Our ref
PLAN-040458

Date
10/08/2021

Proposal: Change of use of part of site to car wash including siting of cabin and canopy. This application may affect the setting of a listed building & is in CIL Zone 5 (Zero Rated) as other development.

Site: CM/34/21/PL: - Maidenhead Aquatics, Crookthorn Lane, Climping BN17 5SN.

Southern Water MapGuide Browser

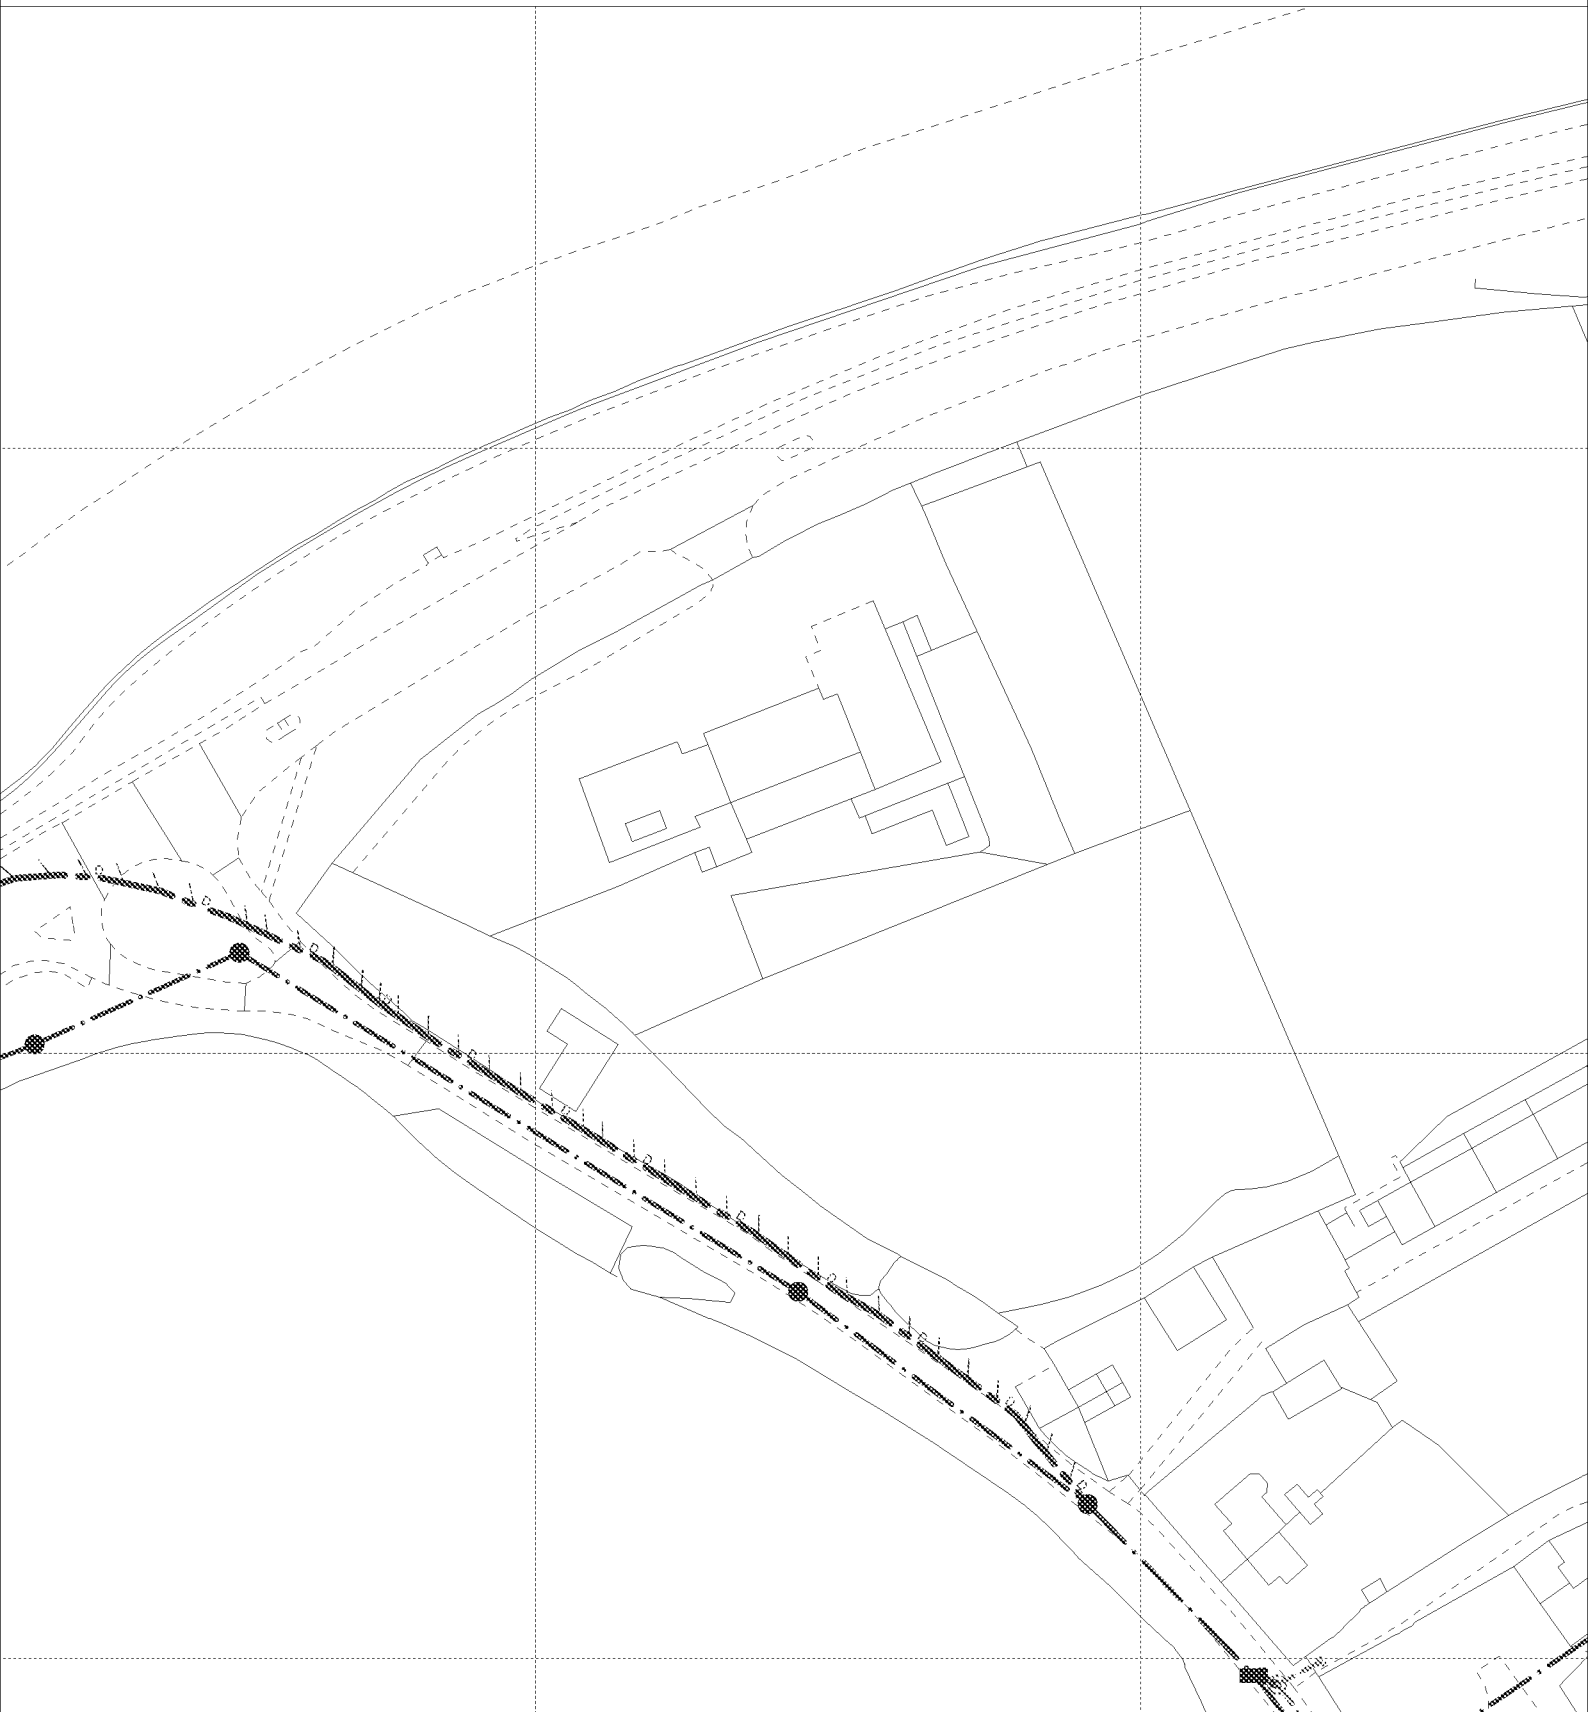
It is possible that a sewer now deemed to be public could be crossing the development site. Therefore, should any sewer be found during construction works, an investigation of the sewer will be required to ascertain its ownership before any further works commence on site.
